THE EDWARD R. JAMES COMPANIES

1725 WINNETKA AVENUE

ENGINEERING: STAFF COMMENTS AND RESPONSES

Proposed On-street Parking

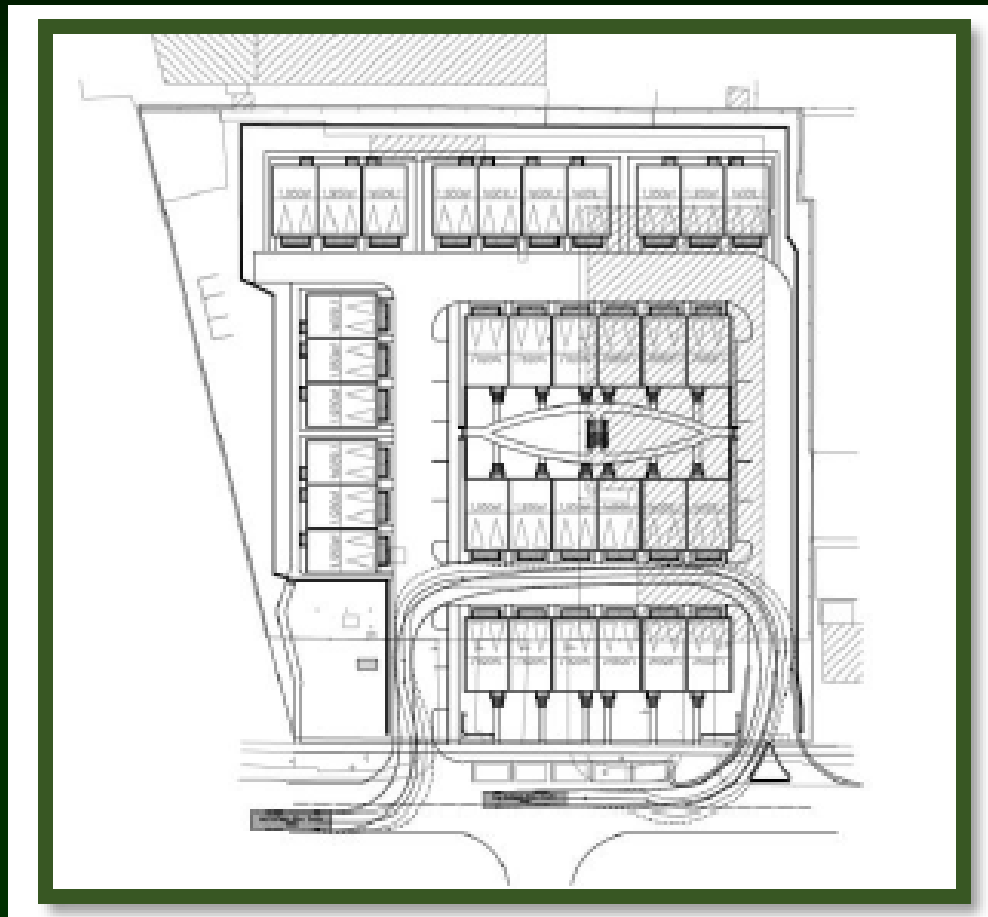
10. Due to the posted speed limit of 35-mph on Winnetka Road, the proposed five on-street parking spaces on the north side of Winnetka Road are a safety concern. Vehicles performing parking maneuvers will force rather high speed through traffic to stop quickly and usually unexpectedly.

GHA July 26, 2017 Update: We are still concerned about on-street parking maneuvers conflicting with the Winnetka Road relatively high speed through traffic.

Response: We would like to further explore the possibility of this potential improvement with the Village and the County. As of now, the spaces are still shown on the plan with the understanding that further review and discussion regarding safety would need to occur.

9/5/17 Response: The plan contains 12 on-site guest parking spaces, and complies with required parking ratios per the ordinance. As such, we will remove these spaced from the plan. We will still, however, seek to work with the County to repair and enhance this section of right-of-way and pavement across the frontage.

FIRE TRUCK TURNING MOVEMENTS

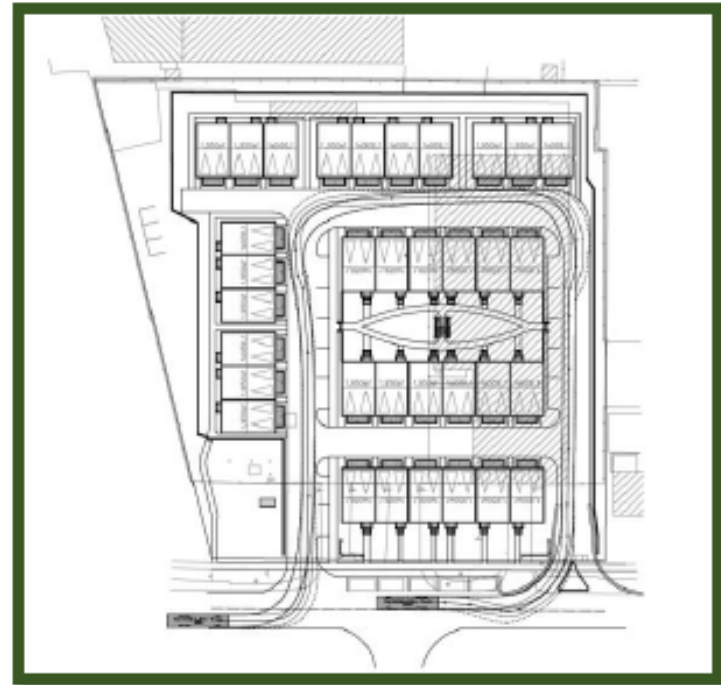
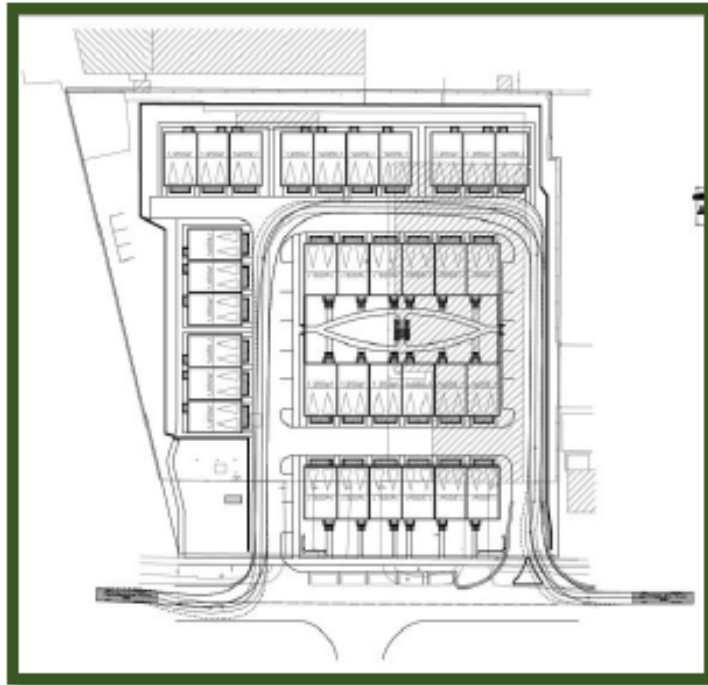
9. The fire truck turning exhibits appear to indicate that there will be some encroachment beyond the private street pavement.

GHA July 26, 2017 Update: The fire truck turning radius is acceptable. An additional AutoTurn should be run for Units 7, 8, and 9 in the northwest corner of the site, to ensure that the 16-foot wide pavement can accommodate turns in / out of the garages. Please provide this information when it is available.

Response: The fire truck encroachment is the overhang of the vehicle. The wheel tracks are within the pavement. The truck turning radius exhibit has also been overlain on the landscape plan as shown on Exhibit H2, and as a result a few minor revisions to the landscape plan shown as Exhibit G1 have been made.

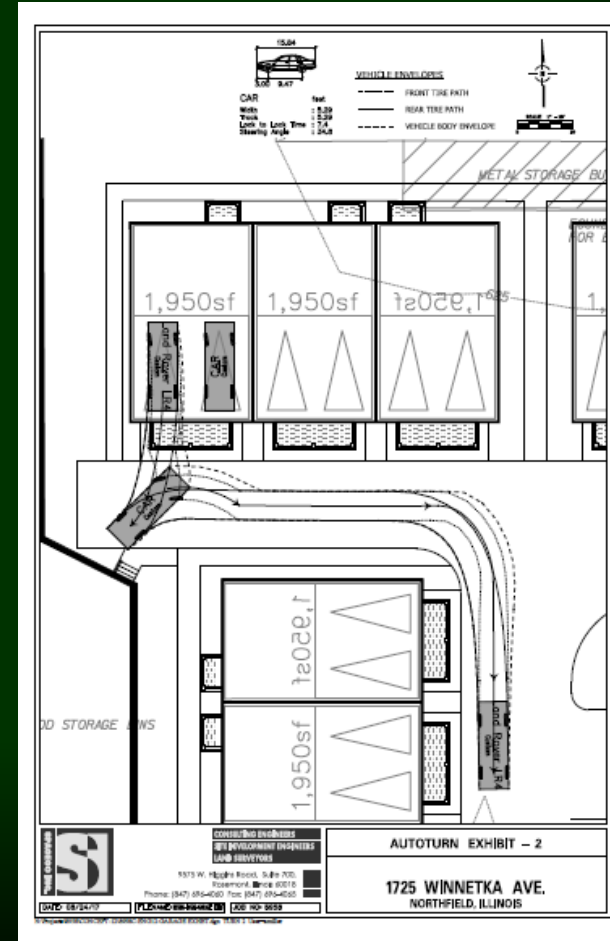
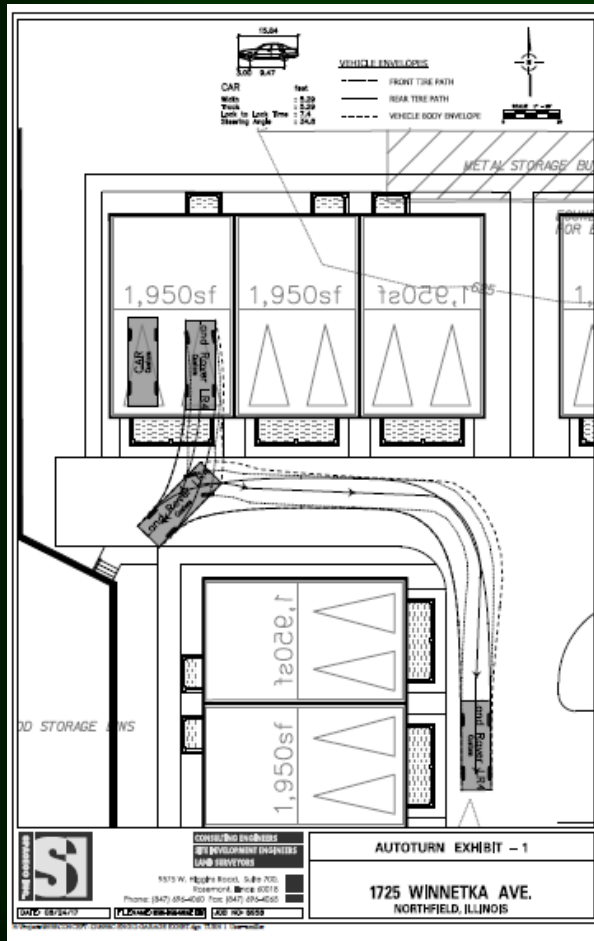
AutoTurn should be run for Units 7,8,and 9 in the northwest corner of the site, to ensure that the 16-foot wide pavement can accommodate turns in/out of the garages.
